DOCKETED	
Docket Number:	22-AAER-01
Project Title:	Commercial and Industrial Fans and Blowers
TN #:	242653
Document Title:	Armin Hauer Comments - greater or equal FEI
Description:	N/A
Filer:	System
Organization:	Armin Hauer
Submitter Role:	Public
Submission Date:	4/12/2022 1:14:26 PM
Docketed Date:	4/12/2022

greater or equal FEI

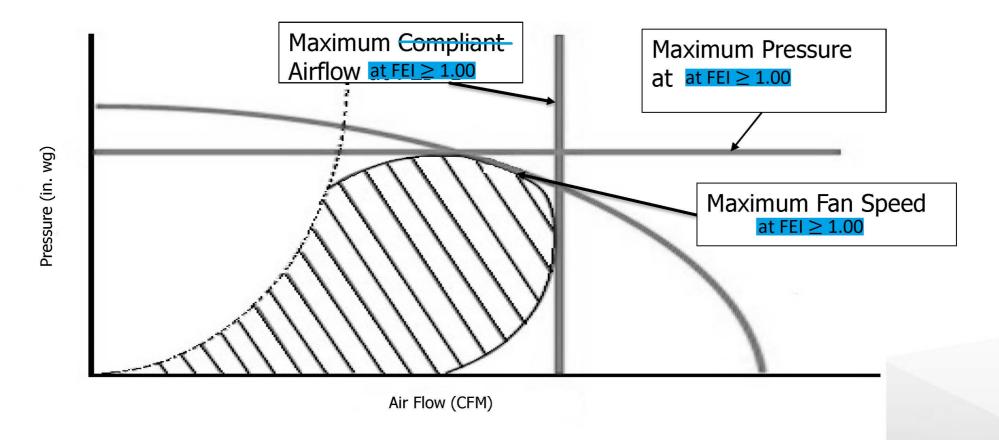
Highly efficient fans of certain aerodynamic characteristics or of limited structural strength may not be operable where FEI equals 1.00. The "equal sign" therefore ought to be substituted with the "equal or greater sign" in (a) the illustration, (b) regulatory language \hat{A} 1606 Filing by Manufacturers, and (c) \hat{A} 1607. Marking of Appliances. - see my markup of today's presented illustration attached

AMCA 214 Annex H describes all related scenarios well.
